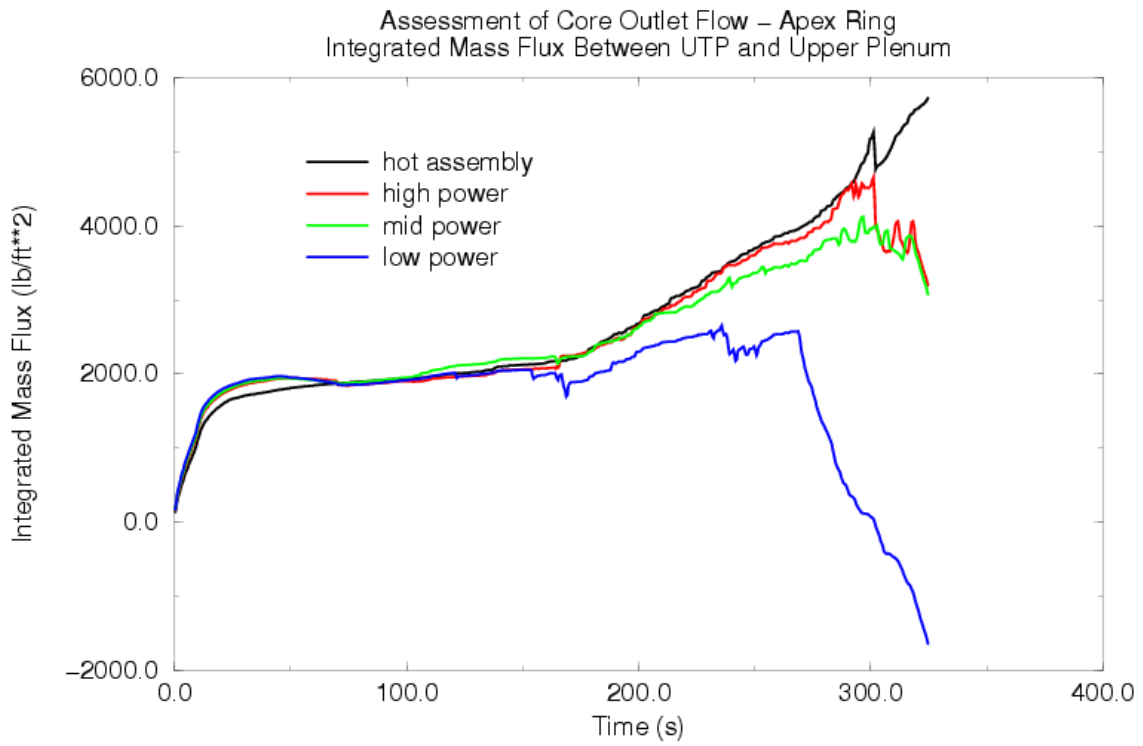
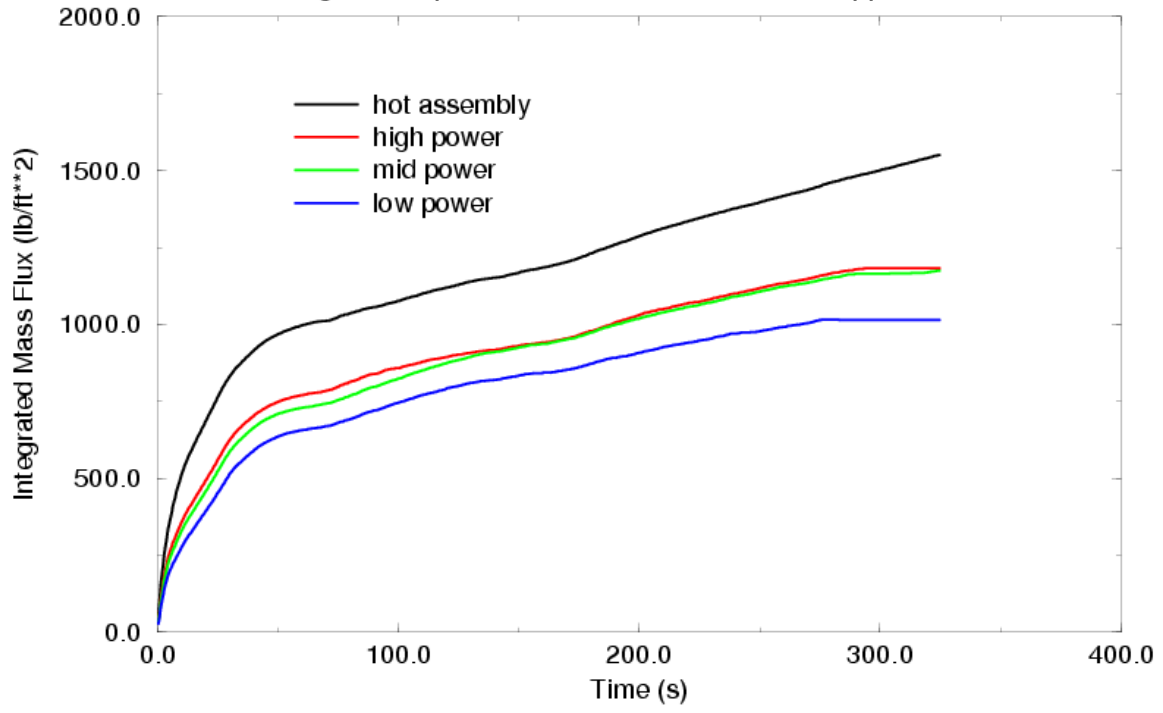
31. NRC staff seeks to understand which channels are in different flow modes for one or more demonstration cases.

Results from BWR/6 large break demonstration case from Section 7.7.6 (1.0 DEG, Pump Suction, SF-LPCS, mid-peaked) are plotted below showing the integrated mass fluxes at the exit of each core channel. [

]. The first three figures show the integrated total, liquid and vapor mass flux for the [
